2.1 NEW S73 APPLICATION - EXTERNAL CHANGES (CONTINUED)

2.2 NEW S73 APPLICATION - INTERNAL CHANGES

Figure 17 - Amended section A-A (subject of this S73 application)

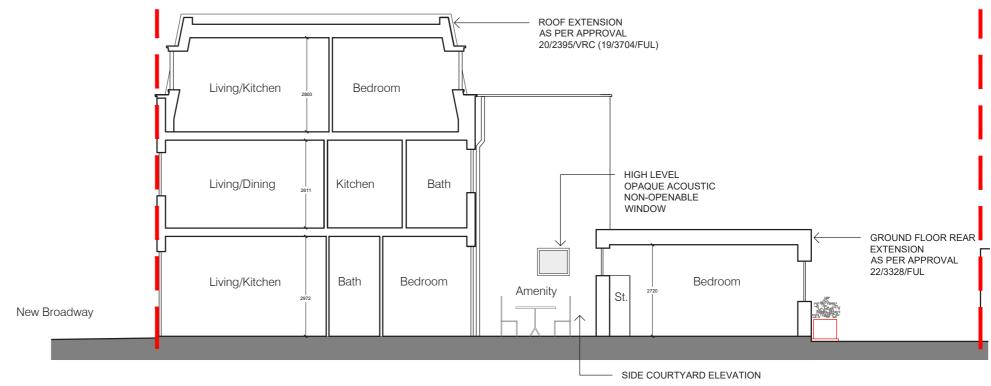
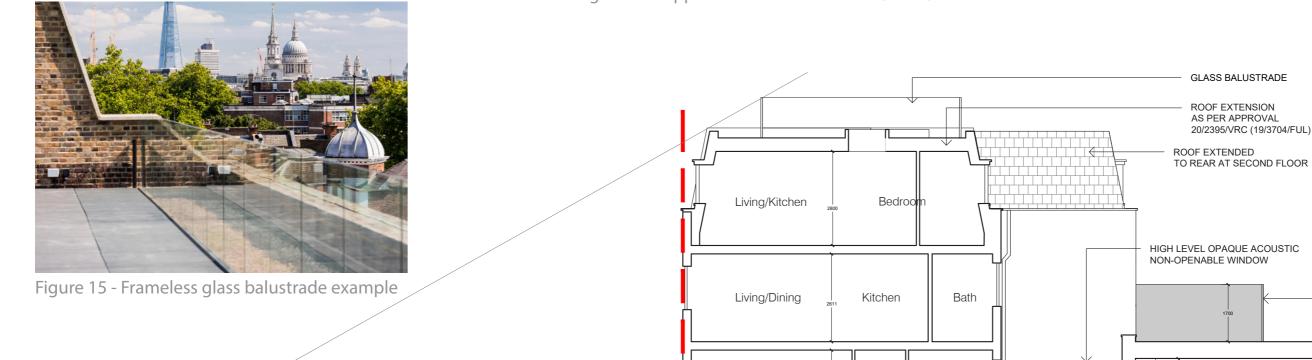
TERRACES WITH
1.7M OPAQUE SCREEN

RAISED PARAPET 250mm

- (H) Raised parapet around the ground floor rear extension (250mm above approved) to accommodate falls.
- (J) Introduction of glass roof lights and PV panels on second floor roof (outside of proposed terrace zone) to gain additional natural daylight/sunlight and improving internal accommodation.

Figure 19 - Amended partial ground floor plan (subject of this S73 application)

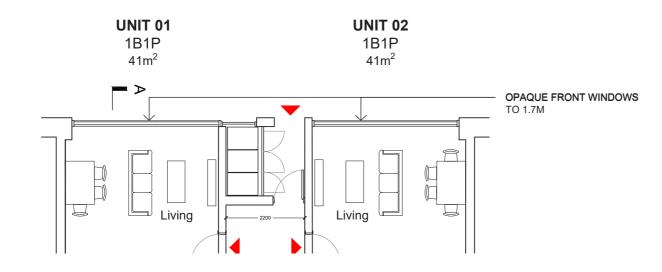
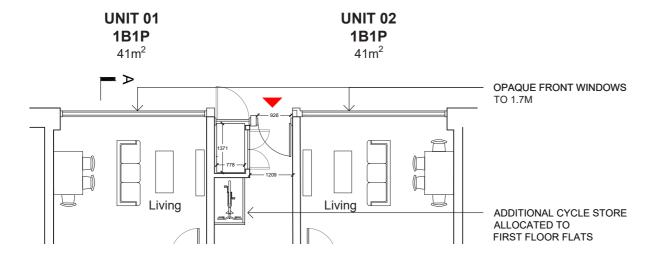
- (E) Introduction of a gate in the rear ground floor railings to allow Unit 3 (largest flat in the proposed scheme) direct access to recycling bins via the external amenity space.

- (F) Repositioning of front door towards street for security reasons and introduction of bin door openings within entrance hallway. Refer to Figure 18 and 19 comparing the approved arrangement and new arrangement.

Figure 21 - Amended second floor plan (subject of this \$73 application)

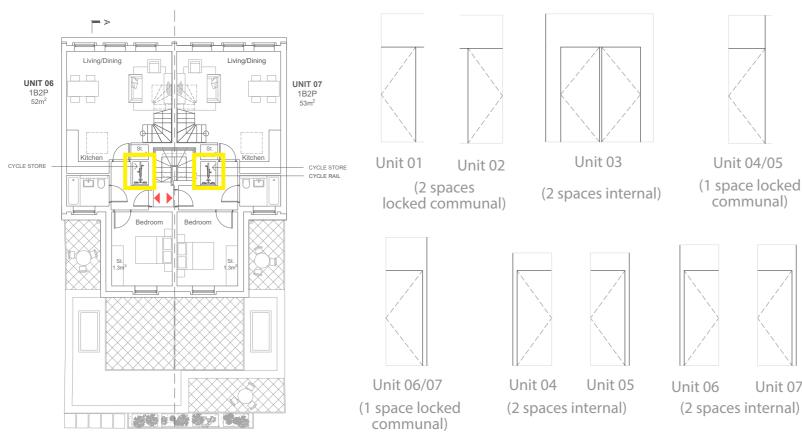
- (N) Compliance with cycle parking. There are 10 cycle parking spaces required in accordance with The London Plan 2021 (refer to Figure 23) and 10 spaces are provided (refer to highlighted portions of Figure 20 and 21).

Figure 25 - Amended second floor and roof plan (subject of this S73 application)

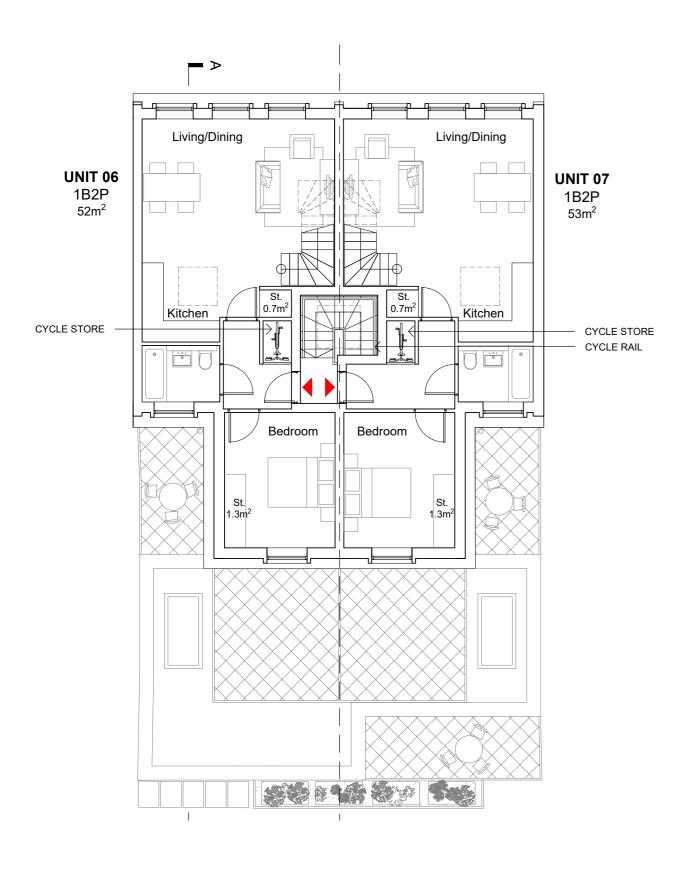
Accordingly, pursuant to Condition U0183817 (U0165001 PV Panels) of Planning Permission Ref: 24/0568/VRC, it is proposed to install 11 x 540W Sharp Nu-Jd Monocrystalline Solar Panels (MCS Certified) as per the following allocation:

All panels will be south facing with a tilt of 35 degrees from the horizontal.
